## **Appendix A : Uisce Éireann Statement of Design Acceptance**

**Re: Design Submission for Site at, Whitestown Road, Dublin, Dublin  
(the “Development”)  
(the “Design Submission”) / Connection Reference No: CDS25005245**

**ROAD SAFETY AUDIT REPORT**  
**CLIENT: DBFL CONSULTING ENGINEERS**  
**PROJECT TITLE: WHITESTOWN WAY TALLAGHT**  
**REV 0**

This report is a Stage 1 Road Safety Audit of the proposed development at Whitestown Way Tallaght, Dublin.

designed by	author	scale	sheet size
NCG	CK	1:500	A1
drawing no.	revision		
240192-X-05-Z00-XXX-DR-DBFL-CE-1300			1

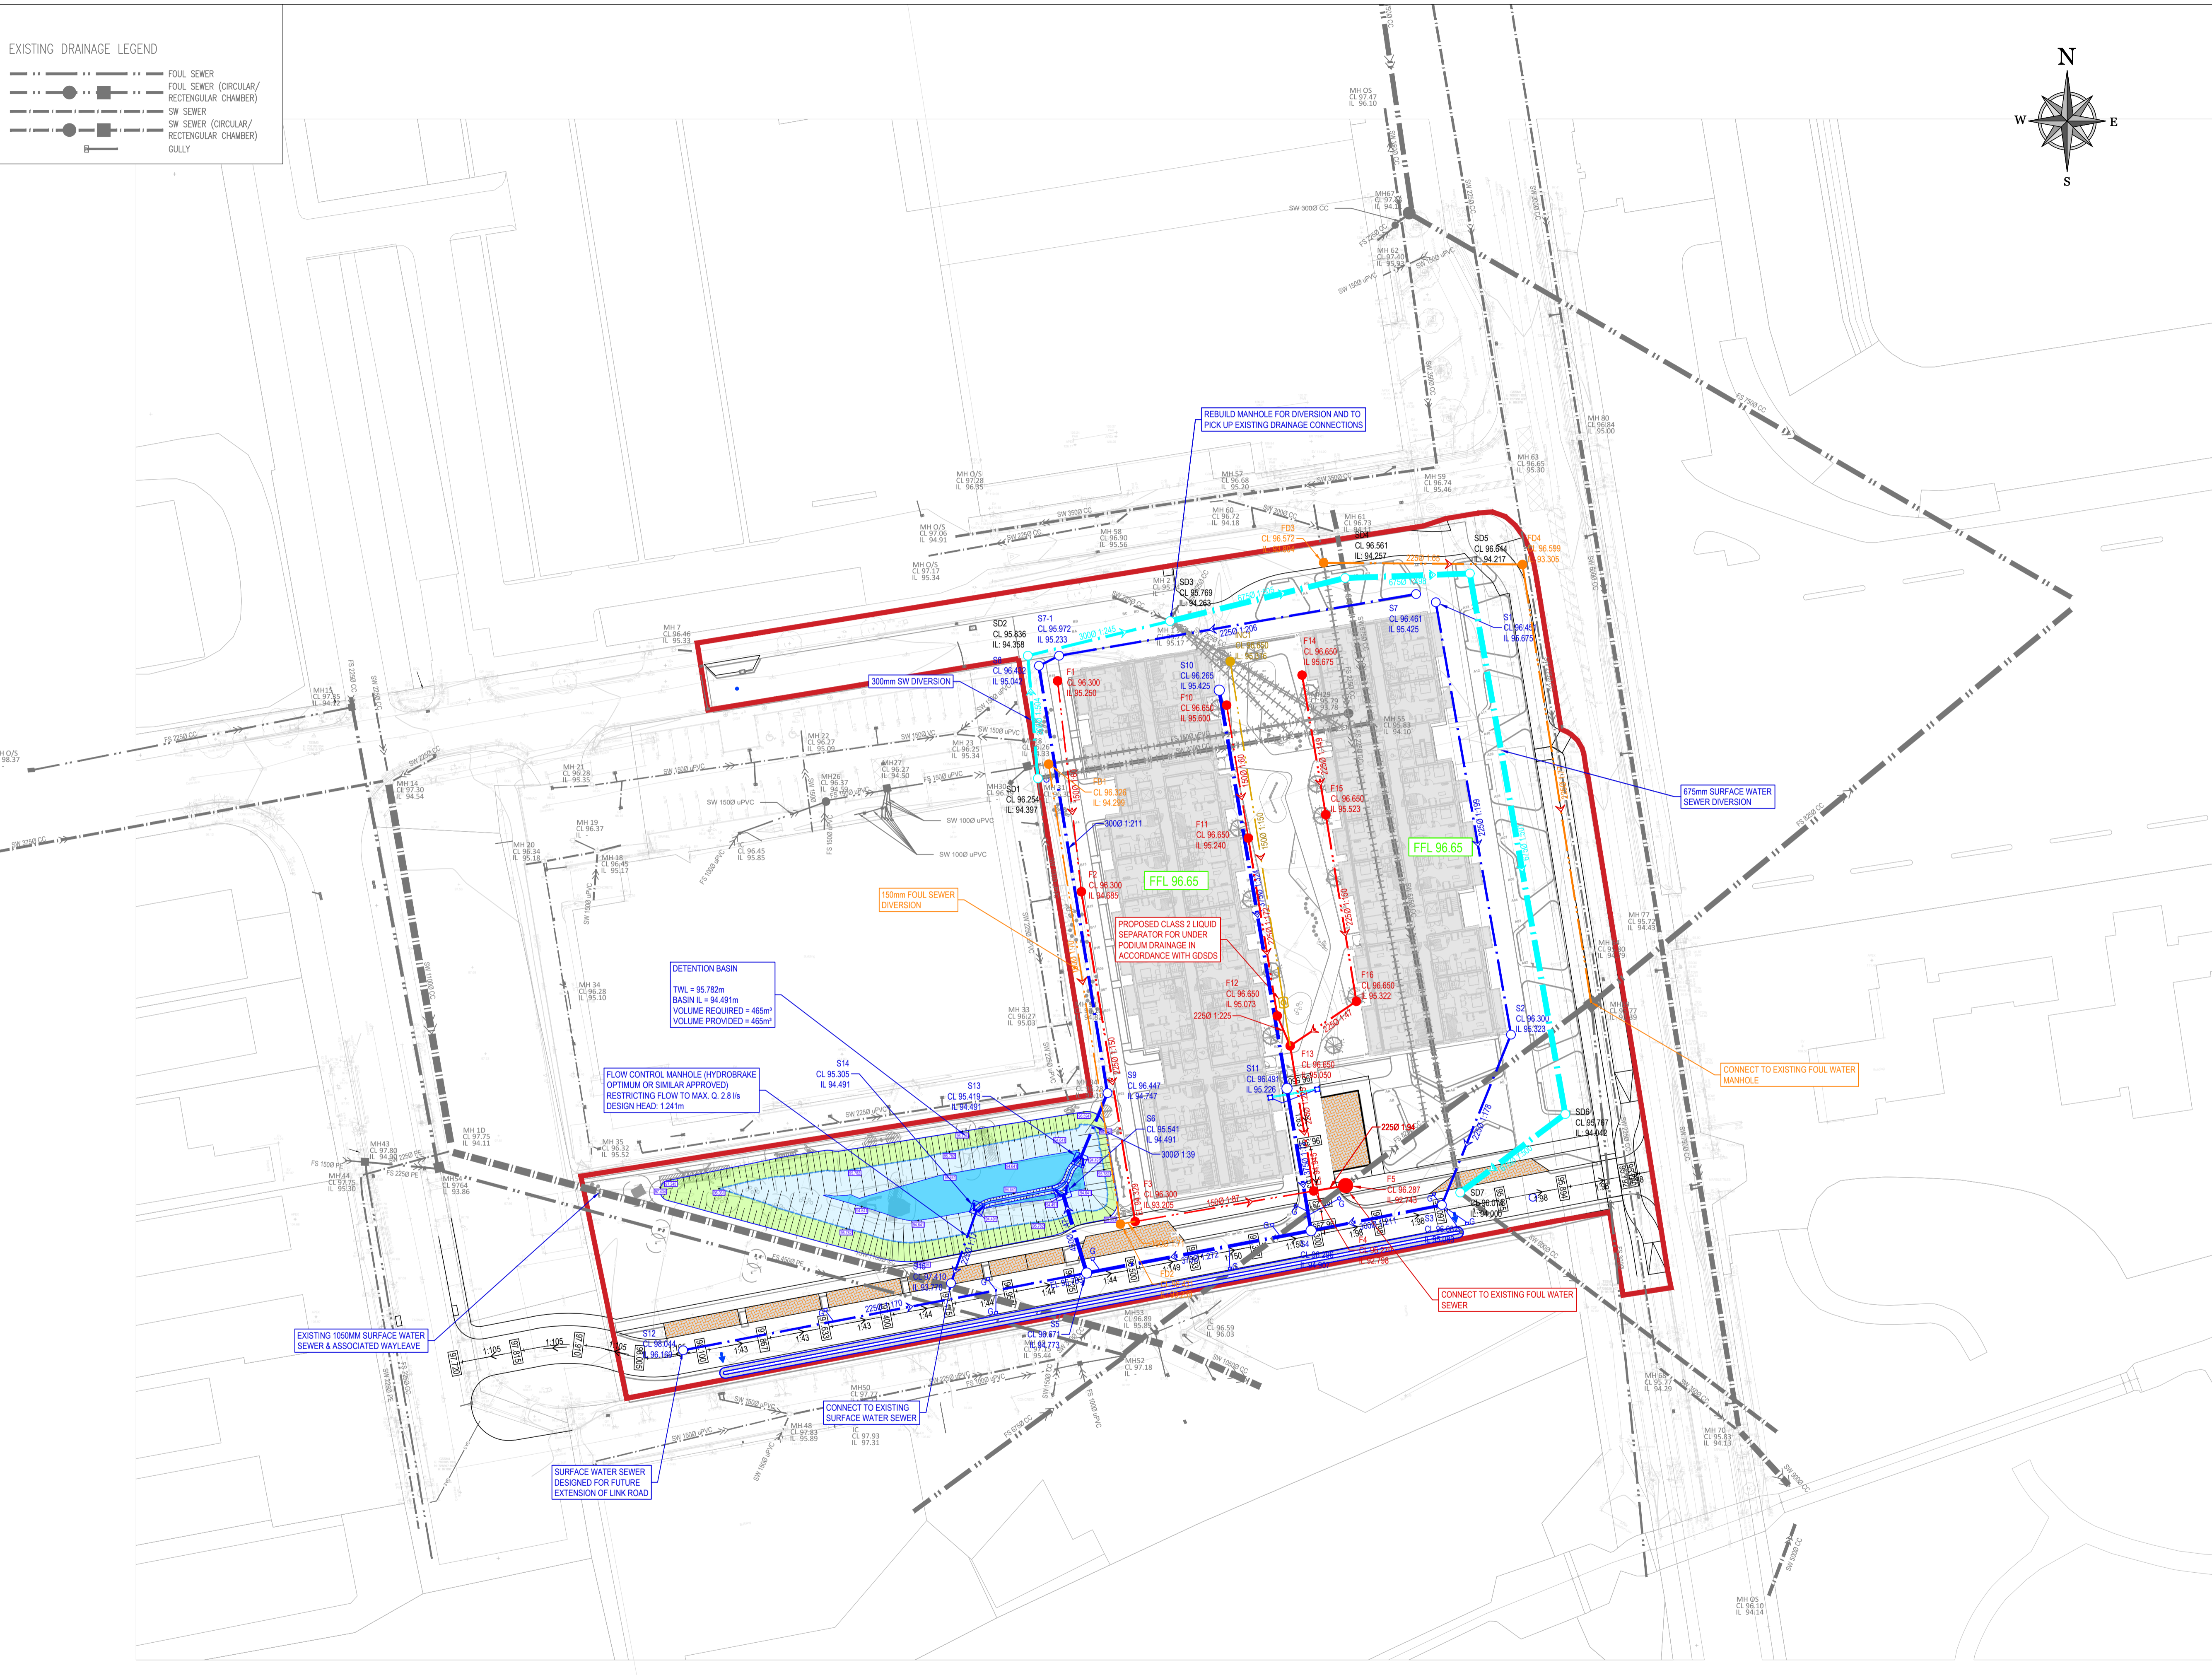
1. *Uisce Éireann notes that the diameter indicated for the foul sewer between manholes F3 and F4 is inconsistent with the proposed network and is likely a drafting error. The applicant shall review and amend the pipe diameter and submit updated drawings reflecting this correction at Connection Application stage.*

Figure 6.1 Proposed Layout

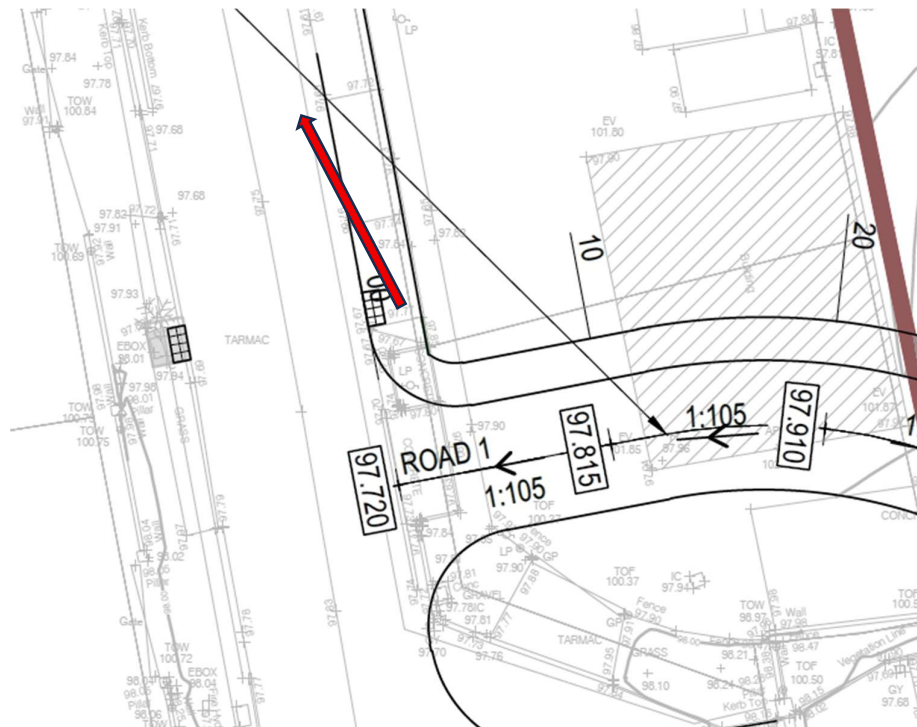
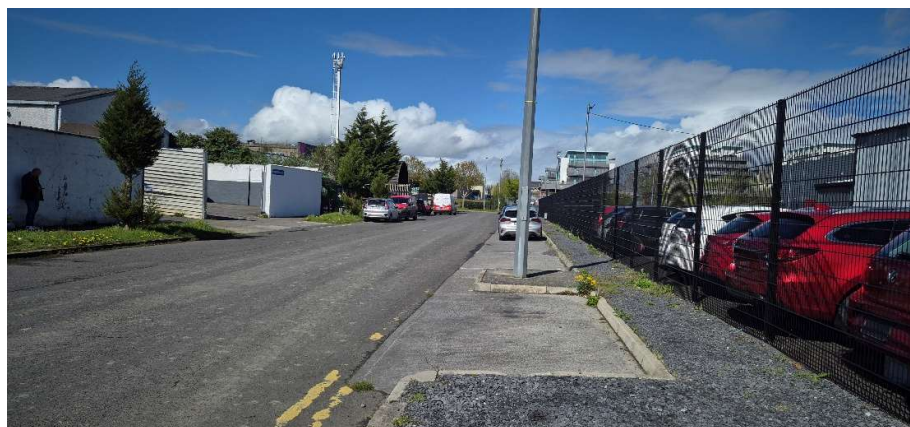
**6.1 Problem: Lack of visibility at pedestrian crossing**

**Location: Southwest corner of site**

Intervisibility between pedestrians and approaching vehicles at the proposed crossing may be obstructed by vehicles parking within adjacent parking spaces. Restricted visibility may reduce driver awareness of pedestrians waiting to cross or already on the crossing, increasing the risk of vehicle–pedestrian collisions.

The parking should be set back at the pedestrian crossing to ensure appropriate visibility is provided at the crossing.

6.1	Yes	No	This section of the road is not being delivered with this planning application as it is 3d party lands. The continuation on the drawing shows that our design does not prejudice the future delivery. The parking will be set back with appropriate visibility when the future extension of the link street is delivered.	Yes

Figure 6.5 Proposed Layout

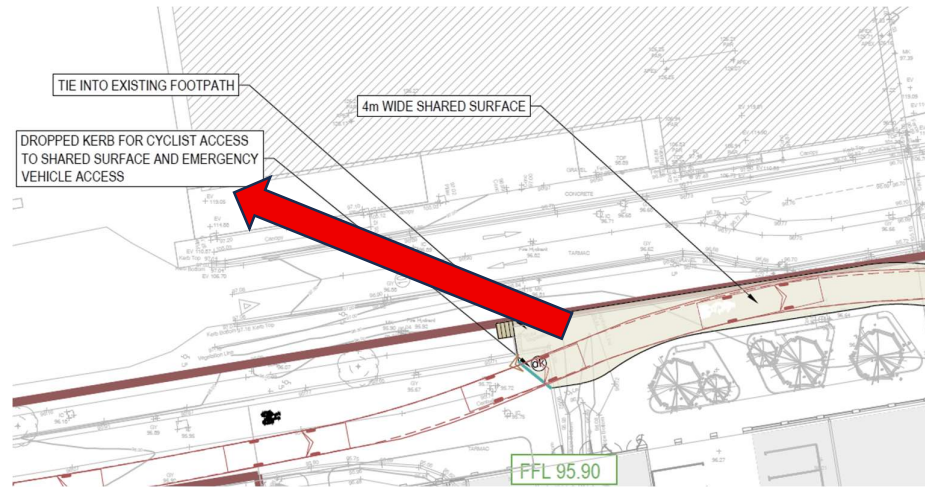
### 6.3 Problem: Lack of pedestrian crossing facilities

#### Location: Arena Shopping Centre

A likely pedestrian desire line exists between the shared surface within the shopping centre and the entrance located to the northwest; however, no formal pedestrian crossing facility is proposed at this location. Pedestrians may cross informally along this desire line, resulting in potential conflict between vulnerable road users and vehicular traffic and increasing the risk of collisions.

Appropriate pedestrian crossing facilities should be provided to accommodate the identified pedestrian desire line. Alternatively, the boundary fencing should be extended to direct pedestrians towards the formal crossing point on Whitestown Way and discourage informal crossing movements.

6.3	Yes	No	This is third party lands. We propose to proceed with the continuation of boundary treatment. We acknowledge that there is a significant level change, as well as existing retaining wall, fence and trees but there is no place to land on the Arena side as there is no footpath on the south of the road.	Yes

Figure 6.6 Proposed Layout

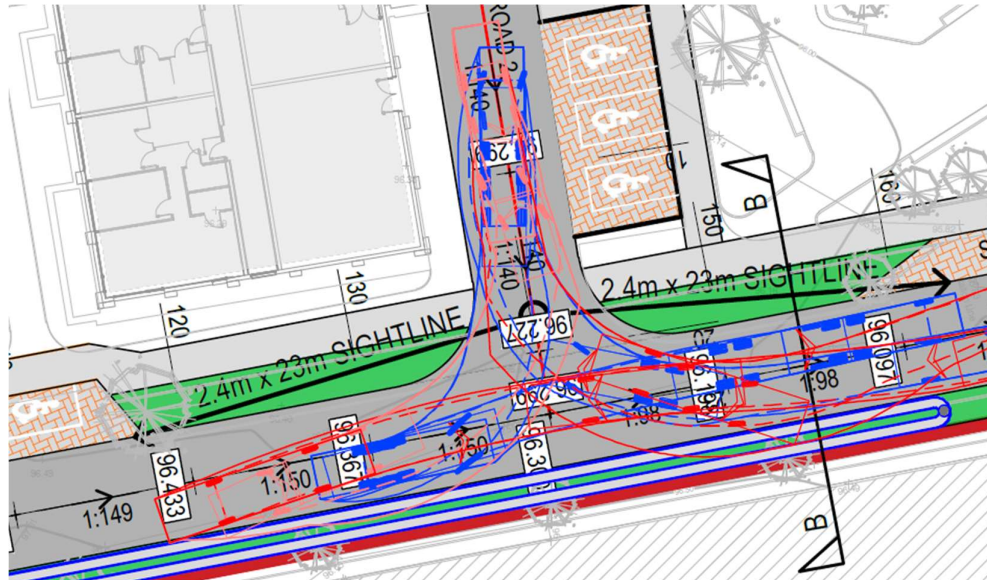
#### 6.4 Problem: Trees Obscuring visibility splay

##### Location: Internal junction

Trees are proposed within the visibility splay of the junction and may obstruct driver visibility. Obstruction of the required visibility envelope may restrict a driver's view of approaching vehicles or cyclists, increasing the potential for side-swipe or other collision types at the junction.

The proposed landscaping should be reviewed to ensure no planting encroaches into required visibility splays. Any necessary planting should be relocated or omitted to maintain clear visibility. Where trees are provided near the junction, species with a high canopy and minimal trunk girth at maturity should be selected to ensure visibility standards are maintained.

6.4	Yes	Yes		
6.5	No	No	The car park shown is an under podium car park which forms part of the building. There is no access for refuse vehicles or emergency vehicles to the car park. Large refuse vehicle and emergency vehicle can turn at the car park entrance. A turning head has also been added at the western end of the link street until the street is made continuous to Whitestown Road in the future.	Yes

Figure 6.7 Proposed Layout

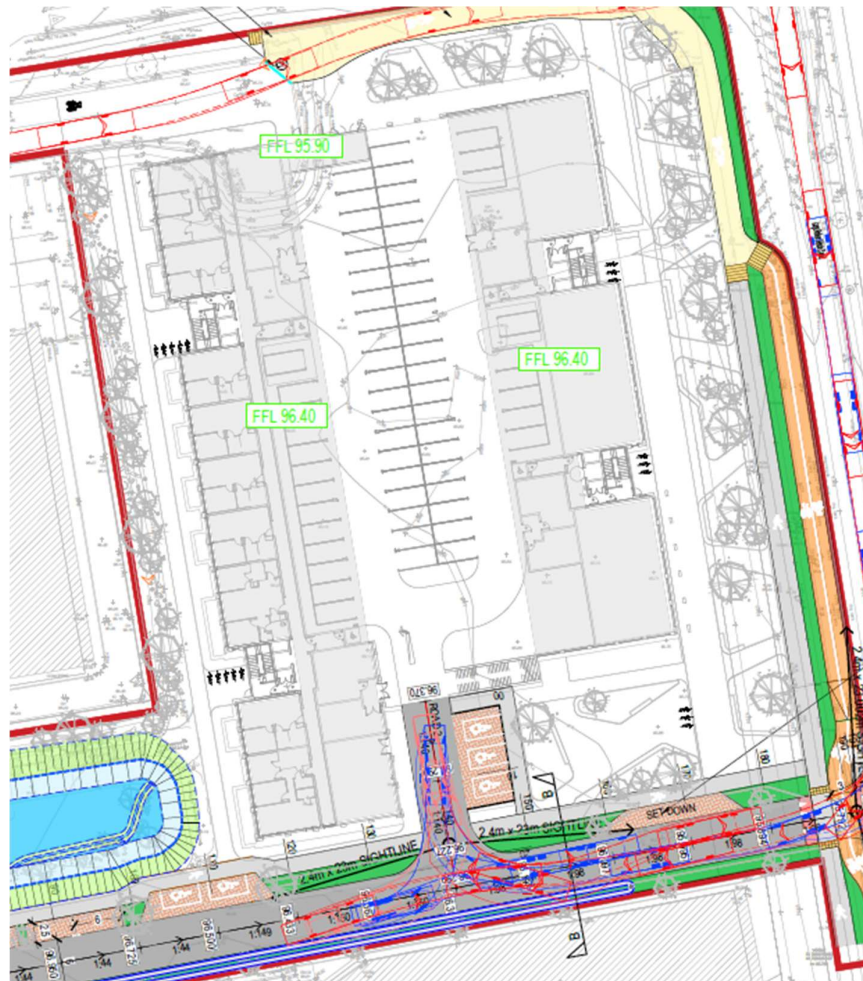
## 6.5 Problem: Lack of turning point for bin truck or emergency services

### Location: Internal layout

No turning facility has been provided within the development for service and emergency vehicles, including bin trucks and fire tenders. Service and emergency vehicles may be required to reverse out of the development, increasing the potential for conflicts with vulnerable road users and other vehicles, and elevating the risk of collision.

A turning point should be provided for larger vehicles.
